CITY OF OAKLAND
APPEAL FORM
FOR DECISION TO PLANNING COMMISSION, CITY
COUNCIL OR HEARING OFFICER

Case No. of Appealed Project: PLN 22189
Project Address of Appealed Project: 5315 COLLEGE AVENUE
Assigned Case Planner/City Staff: NEIL GRAY

Re: Case File No. PLN22189 (5315 College Avenue, APN 014-124901103) –
Appeal of Planning Commission environmental determination on a Minor
Conditional Use Permit for childcare facility for 48 students

Figure 10 - Predicted Play Yard Noise, Base Case

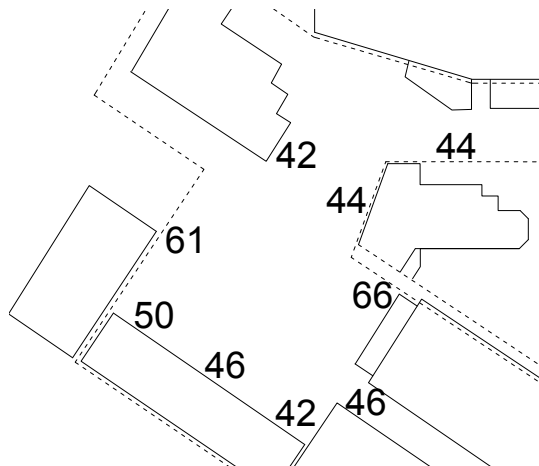
While the effects of shielding provided by the existing building have been taken into account in the Noise Study, the reverberant conditions where the voices reflect between buildings has not been taken into account, and this effect could add another 2 to 3 dBA to the results shown for the Base (Figure 10, page 10).

With a background level around 48 dBA, the project noise from some children in the play yard would be as much as 13 dBA higher than the background (Figure 10, page 10) near the residence at 5324 Manila Ave. This would be perceived as more than twice as loud as the existing background environment.

Figure 12 - Predicted Play Yard Noise With 8' Barrier

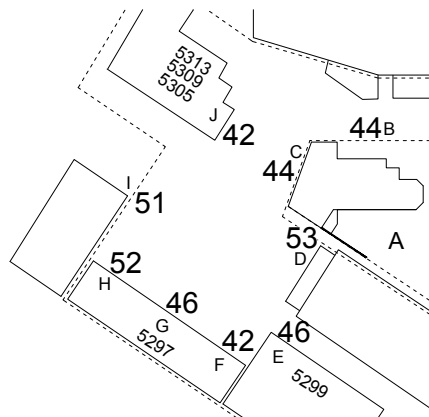
noise results in the Noise Study with the 8 feet high barrier (Figure 12, page 11), the children's voices would be 42 to 52 dBA which would still allow voices to be heard. Since the children's voices would be substantially different in character from traffic on College Avenue or distant noise from Highway 24, the children's voices would be clearly audible at many times of the day.

Figure 1 Background (L₉₉)

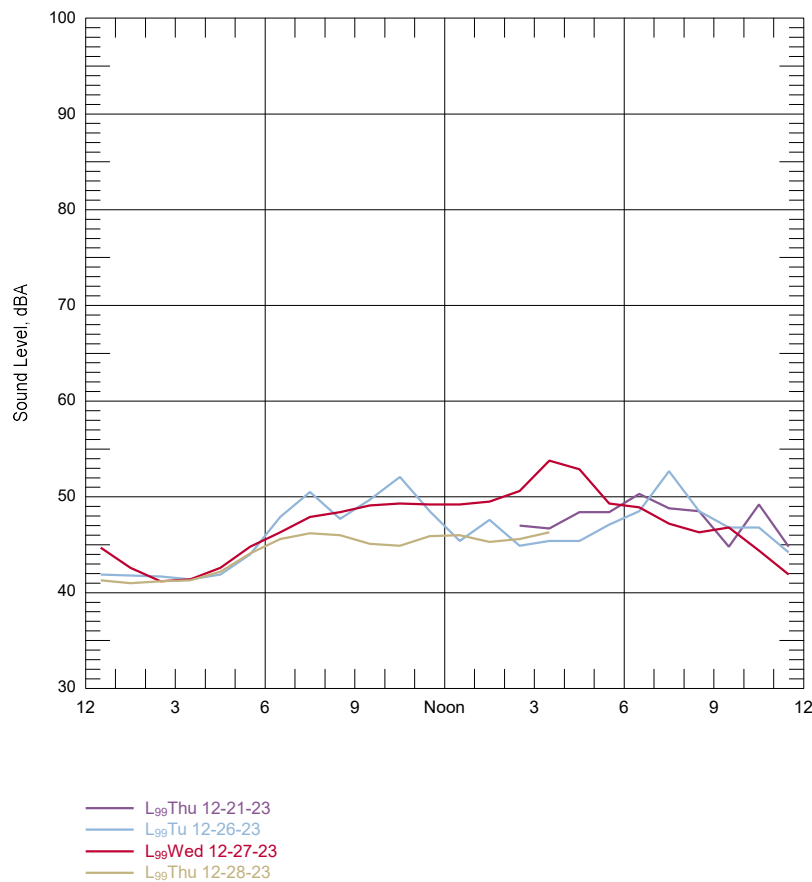
The Noise Study presents statistical calculations measured over several hours in Tables 1a and 1b. Given that the standard of care for a Categorical Exemption is to address potentially significant effects which may be caused by “unusual circumstances”, the Noise Study must characterize worst case scenarios, not typical conditions. Thus, since the neighboring psychotherapy offices rely on quiet conditions it is vital to characterize the existing ambient by identifying the quietest 50 minute periods occurring during project operating hours. Psychotherapy sessions are typically conducted in 50 minute increments, and they do not always start on the hour. The background noise can be characterized by the noise level exceeded 99% of the time, or L₉₉. See Figure 1, which was measured at the porch level of 5309 College Avenue in 2023 on December 21 (partial), 26, 27 and 28 (partial).

Figure 1 – “Base Case”, Sound Children at Play – No Sound Barrier Wall (Typical, L₂₀)

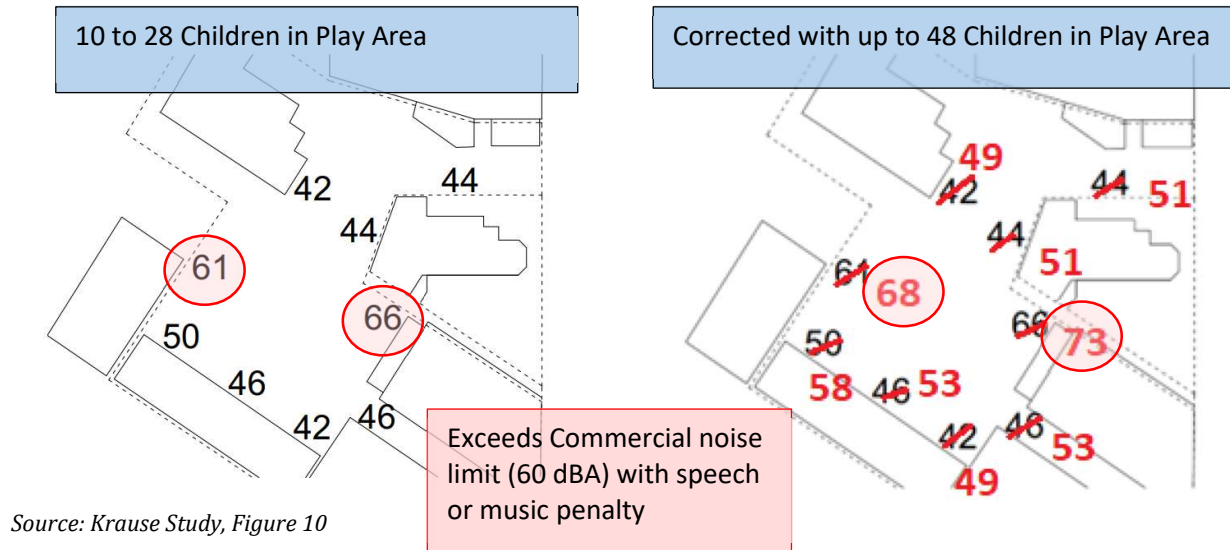
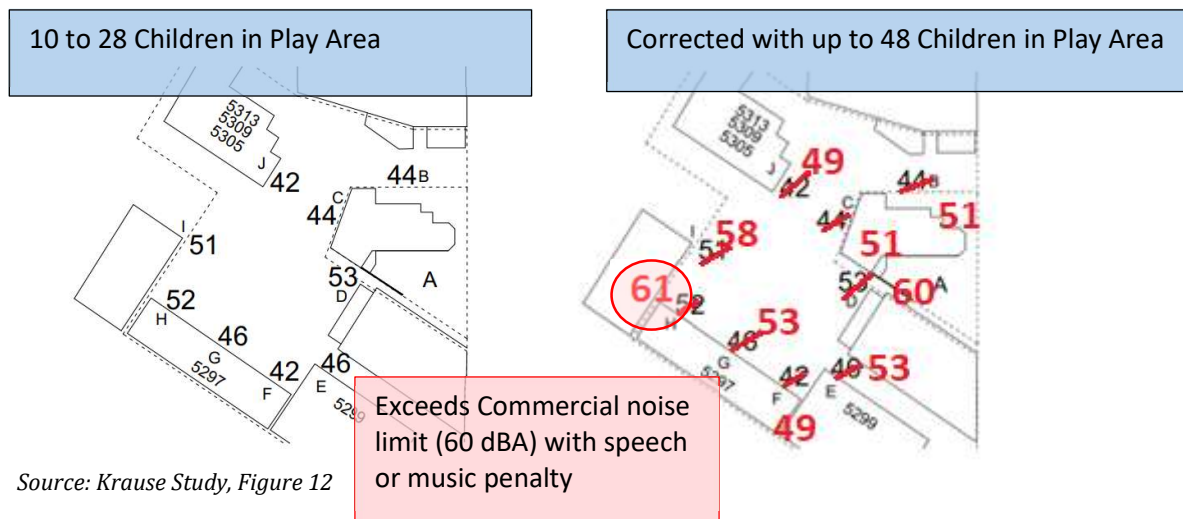
The Krause Study describes an “Alternate Case” that incorporates a sound wall to block noise from the play area, shown in Figure 2. As shown, with the sound wall mitigation except for location H the sound levels on the receiving property would be reduced to 60 dBA or less, even with the correction for the full 48 children. There appears to be an error in the Krause Study, as the noise level at location H *increases* with the sound wall and exceeds the noise limit.

Playground sound that is 10 to 15 dBA less than the background, or residual sound, would approach the threshold for being “inaudible” at all times. The Krause Report identifies a 52 dB “residual sound level” from distant noise sources. As discussed in our prior letter, the average residual sound level can be 48 dBA, lower than that reported in the Krause Report. Thus, to make the claim that the voices from the playground would be “inaudible” requires that the range of maximum sounds from the playground should be no greater than 38 dBA. As shown in Figure 2, with the sound barrier the L20 values from the playground will exceed 38 dBA at all nine modeled receptors by 4 to 23 dBA. Furthermore, the Krause Report identified 77 dBA as an average L01 value, or sound level occurring 1% of the time (30 seconds in a 50 minute session), for a range of 10 to 28 children. These maximum sound events will be **higher** than the values shown in Figure 2 with the sound wall by 10 dBA and comparable to the average traffic noise.

The proposed mitigation recommended in the Krause Report (8’ high wooden sound wall) and adopted as a Condition of approval by the Planning Commission would not be sufficient to reduce noise impacts to less than significant. As shown in Figure 2, one modeled receptor, representing at least two offices, will still experience sound levels that exceed the Ordinance. Furthermore, contrary to the claims in the Krause Report, the playground sounds will be audible as they will exceed the background by as much as 23 dBA, and the levels will be similar to the existing average traffic noise. As Conditioned with the sound wall, the playground sounds will be intrusive and disruptive to the therapy sessions occurring in all nearby offices.

Figure 2 Project Site Frontage (Source: Google Maps)

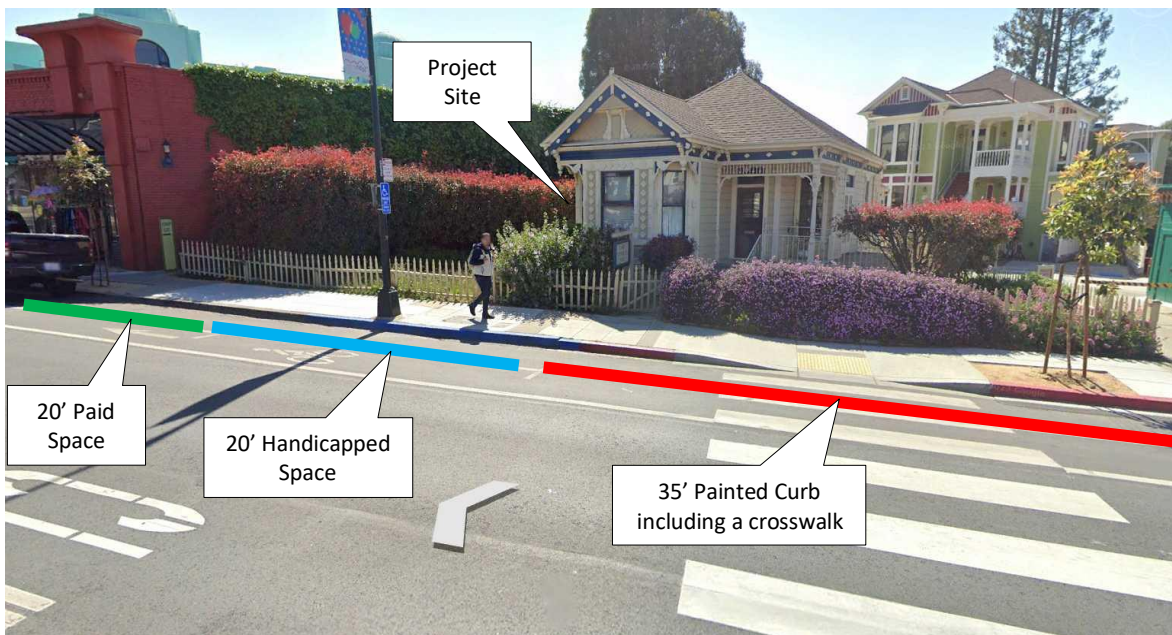
Based on the traffic study provided by the City of Oakland, the proposed daycare center would not provide a drop-off and pickup lane within the site. Parent drop-off and pickup would have to be accommodated in front of the site on College Avenue. Our site review indicated that the entire frontage of the Project is about 75 feet long and has one paid marked parking space and one marked handicapped parking space, plus a 35-foot-long frontage that includes a painted red curb and the pedestrian crosswalk next to the Project site (See Figure 2).
